2018 Mercedes Benz E63S AMG 4MATIC Sed (213.089) V8-4.0L Turbo (177.980)

RETROFIT PROTECTIVE GRILLE FOR ADDITIONAL COOLER

Campaign No. 2019040010, May 2019

SUBJECT: **Model E-Class and GLC-Class (213, 253 platform)**
Model Year 2018-2019
Retrofit protective grille for additional cooler

**Figure 1****Figure 2**

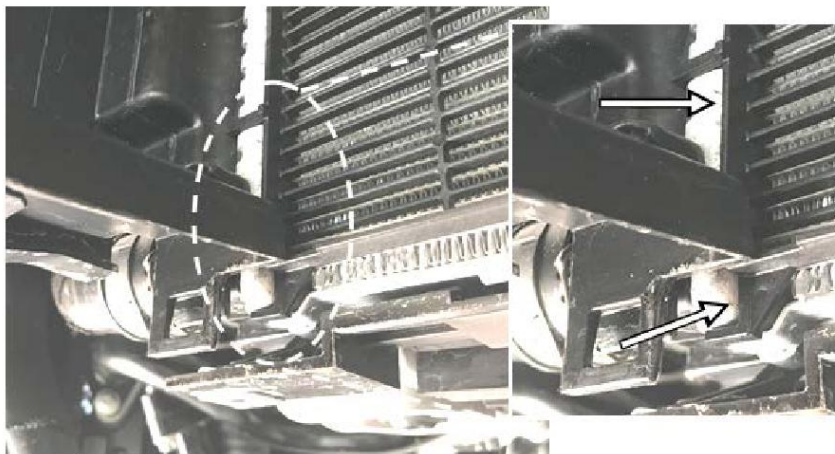
1. Remove front section of engine compartment lining.
 -  For basic data of model 213, see **AR61.20-P-1105LWE**
 -  For basic data of model 253, see **AR61.20-P-1105LW**
2. Unclip additional cooler with connected lines and detach downwards.
 -  Coolant **must not** be drained.
 -  Coolant lines **must not be** disconnected.
 -  For basic data of model 213, see **AR20.20-P-3867MNE**
 -  For basic data of model 253, see **AR20.20-P-3867MNG**
3. Insert protective grille from underneath (**figure 1**) and attach on left and right at corners (**figure 2**) of additional cooler.
 -  Protective grille is mounted flush with the cooler edge.

Figure 3

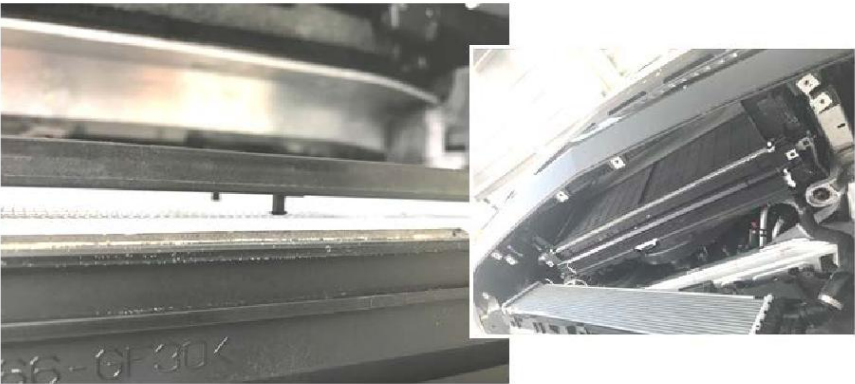
4. Press lugs of protective grille into slats of additional cooler (**figure 3**).
- i

Protective grille is then flush with additional cooler.
- i

There is no contact between the lugs on the protective grille and fluid pipes.
